Access Compliance Report

Public Rights-of-Way

Intersection ID: 21132	Main Street: RED_OAK_BV	Cross Street: W_ARROWWOOD_RD	Location: NE
ADA ID: 2B17DA079584	Ramp Type: PerpDiag	Initial Pass/Fail: Fail	Overall Compliance: No
Codes/Mitigation Info/Possible Solution		Field Measurements/Component Compliance

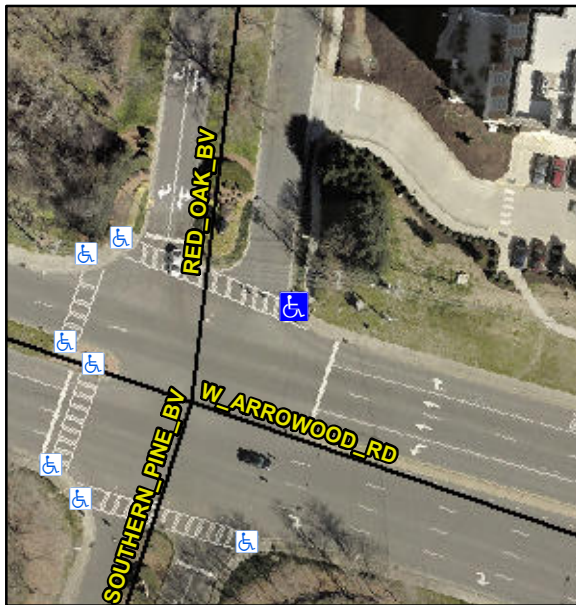
R304.2.2, R304.5.3

Compliance	Description	Data	Compliance	Description	Data
N/A	Ramp Length (in)	66.0	No	Ramp Slope (%)	10.0
Yes	Ramp Width (in)	61.0	No	Ramp XSlope (%)	3.4
N/A	Flare Type LT	N/A	N/A	Flare Type RT	N/A
N/A	Flare Slope LT (%)	N/A	N/A	Flare Slope RT (%)	N/A
N/A	Flare Traversable LT?	N/A	N/A	Flare Traversable RT?	N/A
N/A	Landing Length (in)	N/A	N/A	DWS Provided?	N/A
N/A	Landing Width (in)	N/A	N/A	DWS Contrast?	N/A
N/A	Landing Slope (%)	N/A	N/A	DWS Length (in)	N/A
N/A	Landing X Slope (%)	N/A	N/A	DWS Full Width?	N/A
N/A	Landing Curb? (Y/N)	N/A	N/A	DWS Offset (in)	N/A
N/A	Shared Landing?	N/A			
N/A	Gutter Ponding?	N/A	N/A	Gutter Slope (%)	N/A
N/A	Gutter Lip Ht (in)	N/A	N/A	Gutter X Slope (%)	N/A
N/A	Painted X Walk1?	Yes	N/A	Painted X Walk2?	No
	X Walk 1 Direction	To NW		X Walk 2 Direction	To SW
N/A	X Walk 1 Width (in)	109.0	N/A	X Walk 2 Width (in)	N/A
	X Walk 1 Slope (%)	0.9		X Walk 2 Slope (%)	4.0
	X Walk 1 X Slope (%)	3.5		X Walk 2 X Slope (%)	0.4

Remove & Replace Curb Ramp With Two New Directional Ramps or Equivalent.
